Mandatory Service Bulletin - Wing Pin Washers

SB_SONG_01

24.10.2024

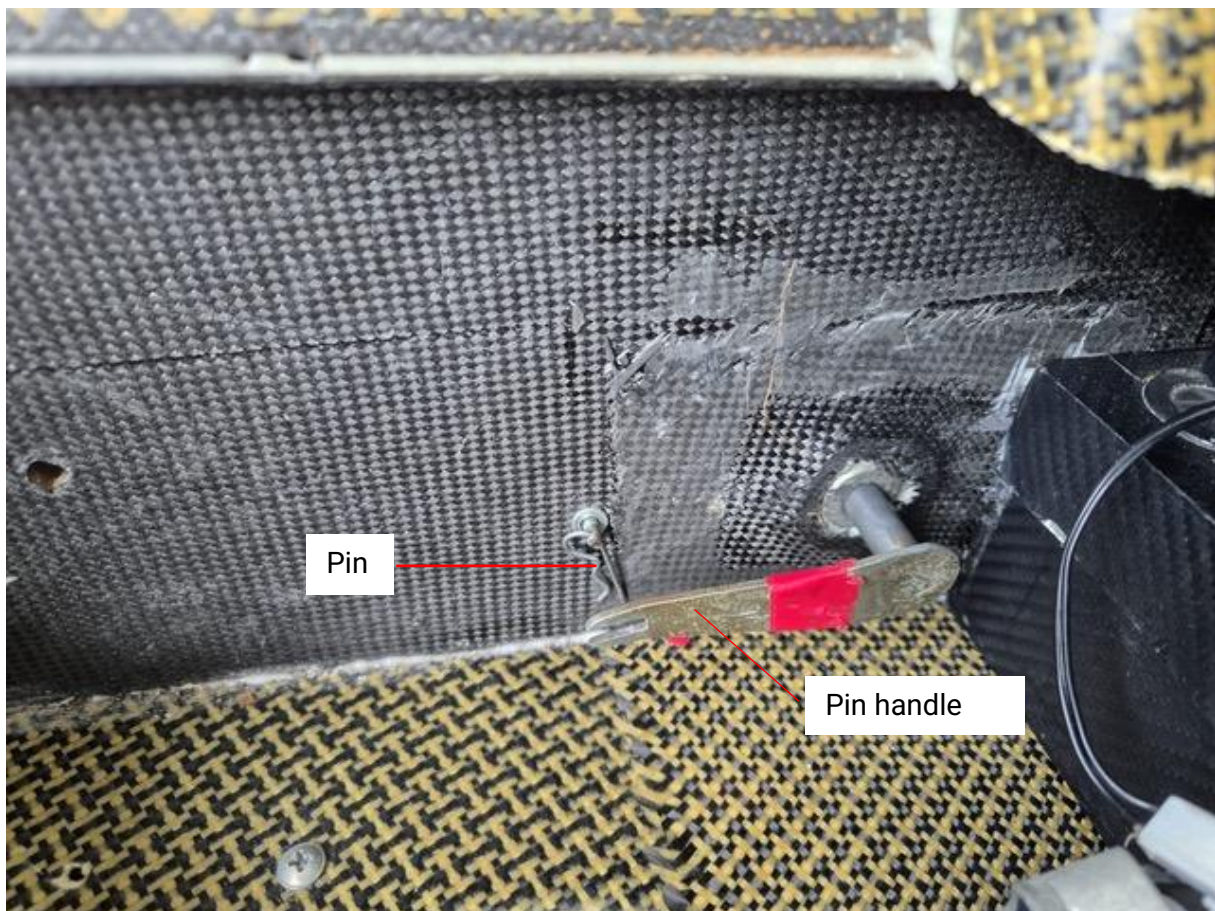
Inner wing pins may got unsecured.

During the preflight check, after the serie of high speed taxing (50km/hod) on the grass RWY a front pin was observed unsecured. Because of vibration, the pin slipped off thru the groove in the pin handle.
